5.0 ADMINISTRATIVE CONTROLS

This attachment provides a brief summary of the changes in Revision D of the proposed Improved Technical Specifications (ITS) submittal for Quad Cities Nuclear Power Station, Units 1 and 2. The original Technical Specifications amendment request (i.e., Revision 0) was submitted to the NRC by letter dated March 3, 2000, as revised in Revisions A, B, and C, submitted to the NRC by letters dated June 5, 2000, September 1, 2000, and December 18, 2000, respectively.

Table 3.3.5.1-1 (page 3 of 6)
Emergency Core Cooling System Instrumentation

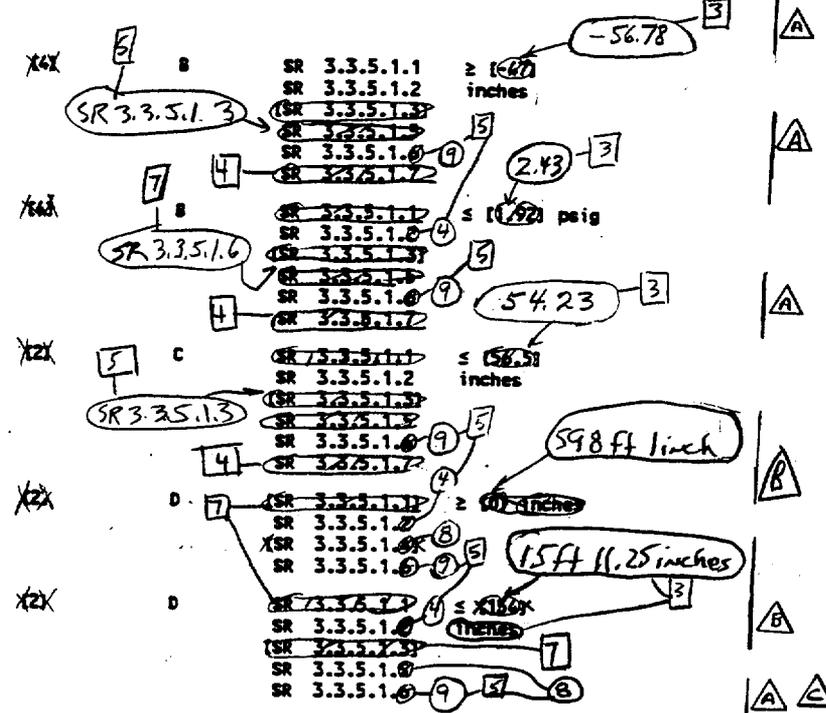
Insert Functions 2g, 2.h, 2.i, 2.j, and 2.k
